## MEMORANDUM

To: Development Review Board  
From: Mary O'Neil, AICP, Principal Planner  
Date: December 21, 2021  
RE: ZP21-509, 72-76 Elmwood Avenue

**Request:** Build three unit detached residential structure on the site of the former Free Methodist Church. One existing single family residence remains on site. (Planned Unit Development)

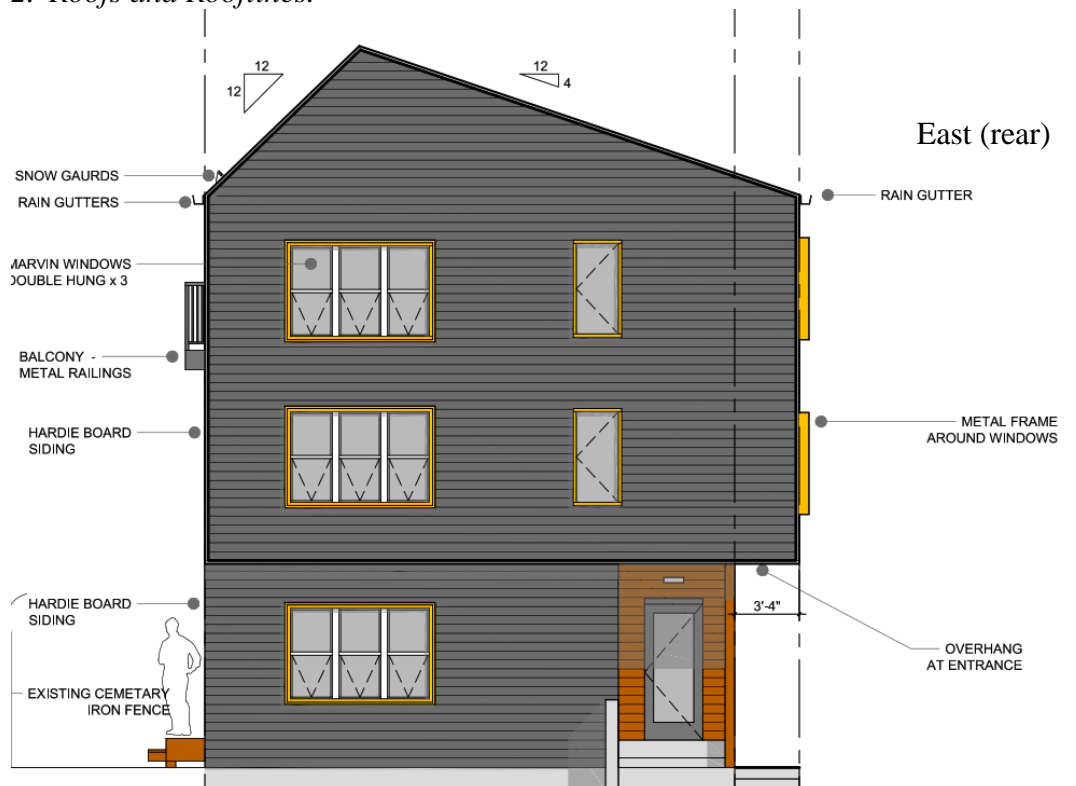
72-76 Elmwood Avenue has only one abutting neighbor; 68 Elmwood Avenue. It is a gable-and-eaves front 2 ½ story residential building. Across the street on the corner of Peru Street is a modified Dutch Colonial, and the much grander St. Joseph’s rectory.

Although presenting eaves-front to the street, the height and massing of the proposed building is consistent with other structures in the immediate area. **Affirmative finding.**

The proposed building has a modified cat-slide roof with dual pitch and minimal eave extrusion. Responding to DAB comments, snow guards and rain gutters have been added on the north and south elevations. In style it reads as a modern infill. **Affirmative finding.**

Fenestration is a mix of triple and double ganged windows and single casements. Sliding doors are noted on the north elevation first floor and third floors.

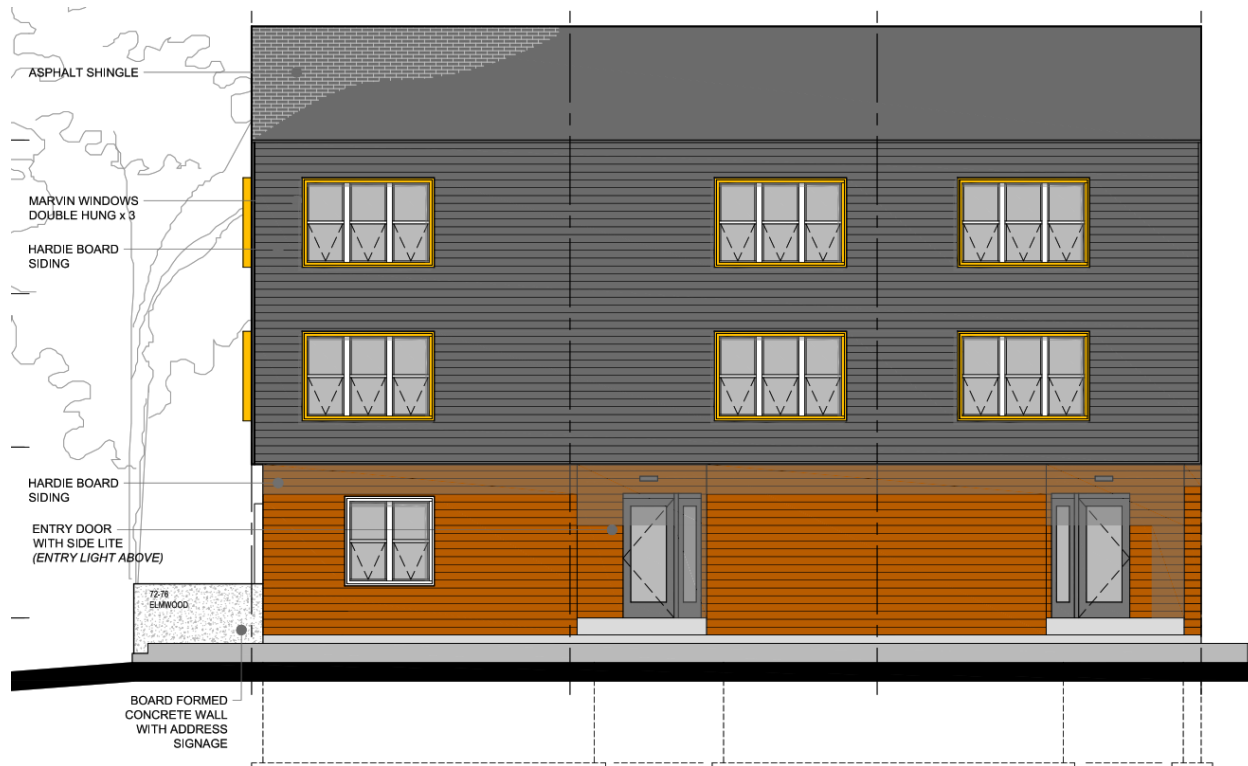
As designed, the building lacks typical façade articulation such as bays, horizontal and vertical façade articulation, porches, patios, articulated bases, step-backs or other street level details. Upon the recommendation of the DAB, a change in plane and color has been introduced between the first and second floor. Windows are stacked, providing a measure of arrangement. The plan is modernistic with a simplified form and measured detailing. The most prominent design component is the angular and asymmetrical roof line, and “framed” window surrounds. Revisions include a differentiated first floor south and west entry, as requested by the Design Advisory Board. **Affirmative finding.**
